**CERTIFICATE OF APPROPRIATENESS**

**Property:** 609 White Street, Tract 7A & 8A-1, Block 145, BAKER WR NSBB Subdivision. The property includes a historic 1,516 square foot, two-story wood frame single-family residence situated on a 3,167 square foot (60' x 56') interior lot.

**Proposal:** Alteration – Addition, the proposed Addition to the residence consists of a two story, 677 SF structure extending behind the west wall of the original house and over the existing one-story structure. The first floor Addition will be 206 SF while the second story Addition will be 471 SF. The Addition is inset on each side (2'-3 1/2") and is covered by a shed roof that extends from below the original ridge at a pitch of 4:12. The new eave will be lower than the original eave but will overhang similarly at 12" and have an enclosed soffit.

SITE/ROOF PLAN

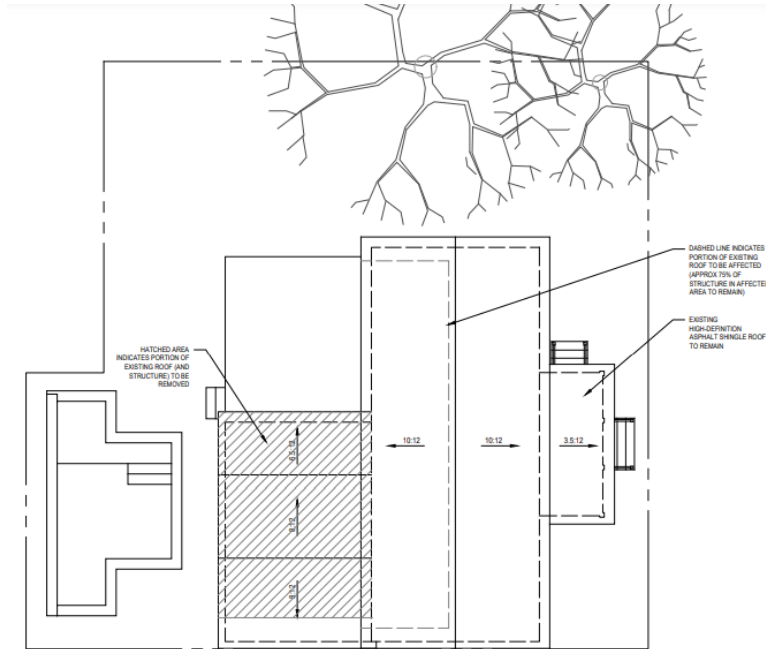
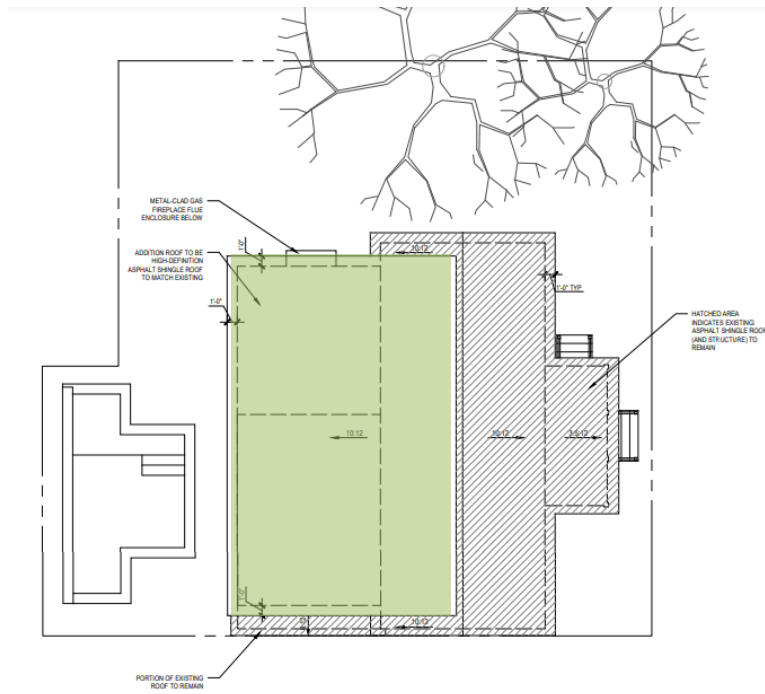
**Recommendation:** **Approval with conditions: that the final roof on the addition be approved by staff.**
